Report on Consultation - Alignment Selection

Chleansaid Wind Farm Connection

REF: 70099990-ALIGNMENT-RPTCONS-001

Title: **Figure 3.1 Preferred Alignment**

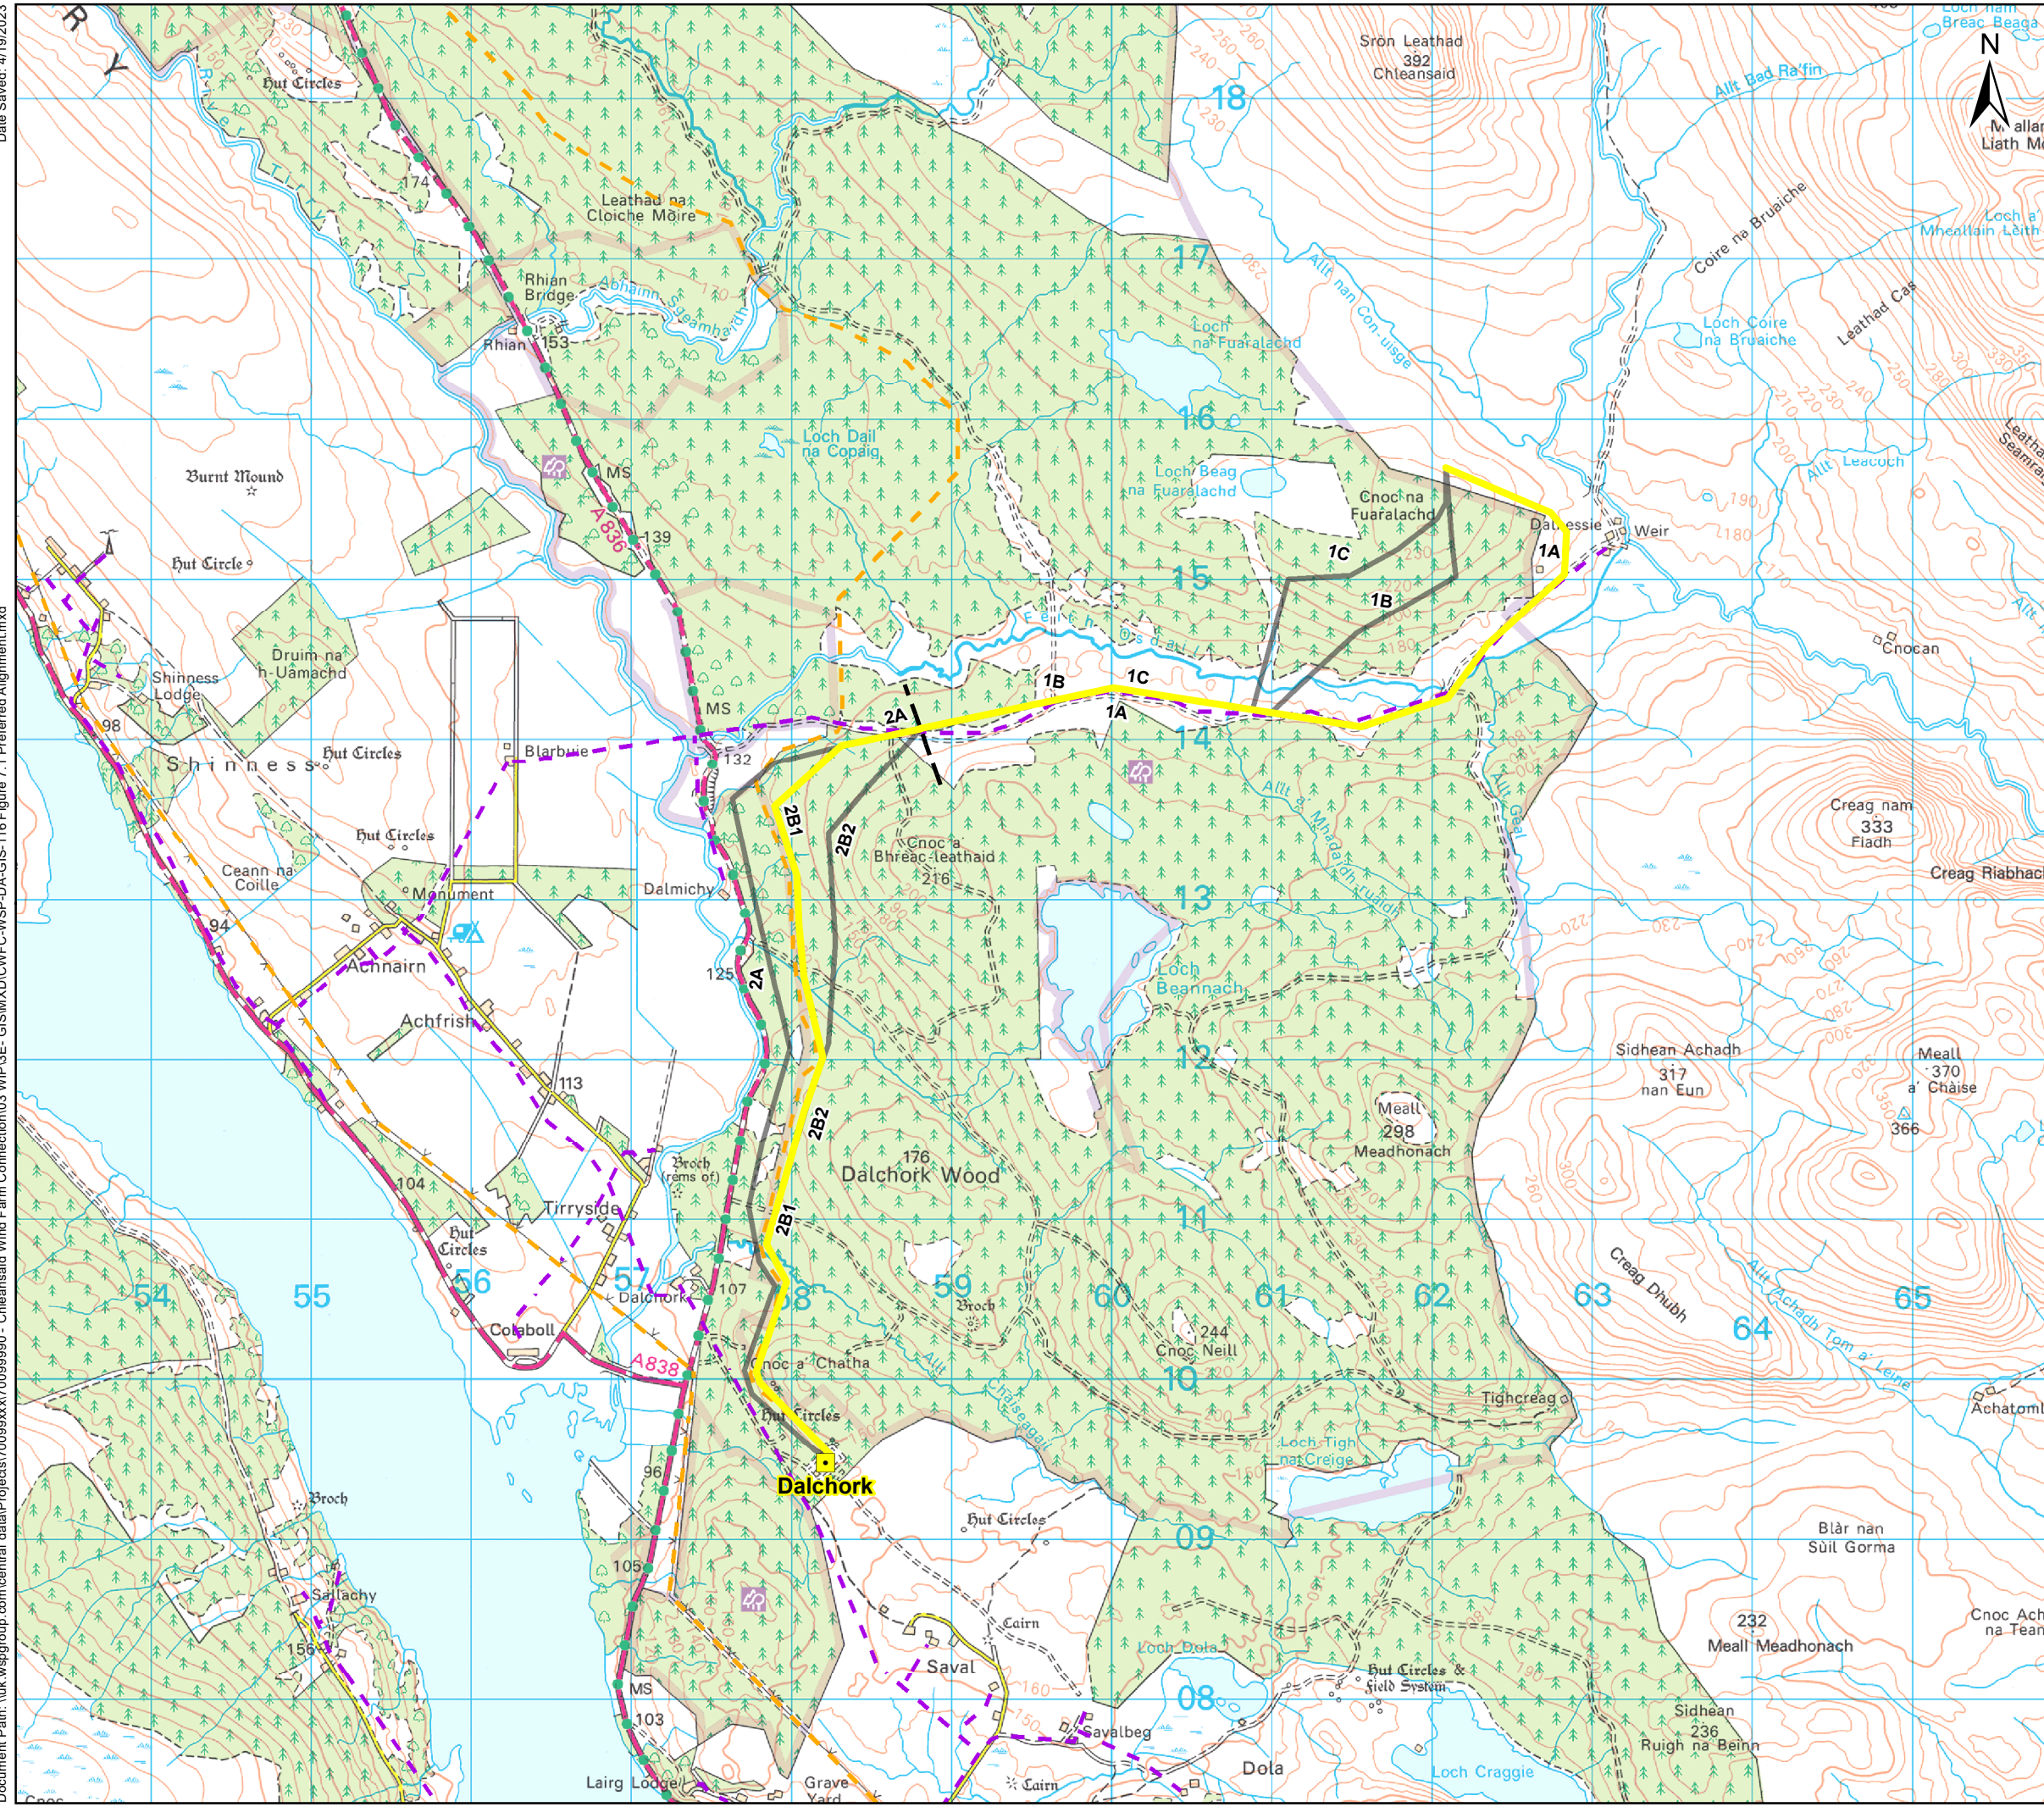
RSPB Scotland	<p>RSPB confirmed they have no available resource to respond in detail at this time. However, route and alignment selection should consider the results of any bird surveys being undertaken. RSPB confirm they are happy to be consulted on the the route and alignments proposed when the bird survey results are available and discuss further with SSEN Transmission.</p>	<p>Noted. SSEN Transmission will share the results from the on-going ornithology surveys with RSPB when available.</p>
SEPA	<p>We note that the preferred option follows the edge of the forestry, then follows the line of an existing track and then an existing OHL. This all seems a sensible approach in relation</p>	<p>SEPA’s comments on the preferred alignment is noted. The requirement to follow the forestry corridor is a key consideration for</p>

JRC Windfarm Coordination	<p>JRC has no comment to make on this application at this time.</p>	<p>Noted.</p>
Scottish Forestry	<p>Scottish Forestry are in general agreement with the selection of the Preferred Alignment. However, Scottish Forestry raise several concerns in relation to the development proposals on nearby forests and woodlands.</p> <p>In line with Scottish Government's wider objective to protect and expand Scotland's woodland cover, applicants are expected to develop their proposal with minimal woodland removal. Woodland removal should be allowed only where it would achieve significant and clearly defined additional public benefits.</p> <p>Scottish Forestry highlight that the need for compensatory planting due to woodland removal should be considered relevant to the proposals. Additionally, several themes within NPPF 4 – Policy 6 Forestry, Woodlands and trees are identified as relevant to this project, which again focus on the need for compensatory planting and the need to avoid loss of ancient woodland and native woodlands.</p> <p>Scottish Forestry welcomes SSEN Transmission commitments to ensure that proposed changes to woodland address the requirements of the Control of Woodland Removal Policy and other relevant guidance. The eastern section of the proposed route appears to impact woodland creation schemes funded by Scottish Government.</p> <p>To inform future scoping and EIA consultation Scottish Forestry advises the developer to include detailed information on the types and areas of forestry to be felled and restocked</p>	<p>SSEN Transmission acknowledge the feedback provided by Scottish Forestry in relation to the Preferred Alignment. As highlighted by Scottish Forestry, SSEN Transmission are committed to ensure that any proposed changes to woodland address the requirements of the Control of Woodland Removal Policy and other relevant guidance. This is an essential part of the design development process, with careful consideration given in the pole spotting process to ensure the requirement for woodland removal is avoided as far as reasonably practicable when finalising the design of the Proposed Development. SSEN Transmission will continue to involve Scottish Forestry in consultation as part of the consenting stage of the project, and will ensure as much as detail as possible around felling and compensatory planting requirements as part of the Proposed Development.</p>

The responses provided largely agreed with the Preferred Alignment (Option 1A and 2B1), and largely agreed with the RAG ratings allocated as part of the combined environmental, engineering and cost comparative appraisal work. The responses provided recognised that the Preferred Alignment runs through a sensitive environment with challenging terrain. However, the Preferred Alignment has been selected on the basis that is considered to provide an optimum balance of environmental, technical and economic factors. Additionally, the responses highlighted the benefit of having sight of detailed design information, such as the grid references of OHL pole locations, once confirmed.
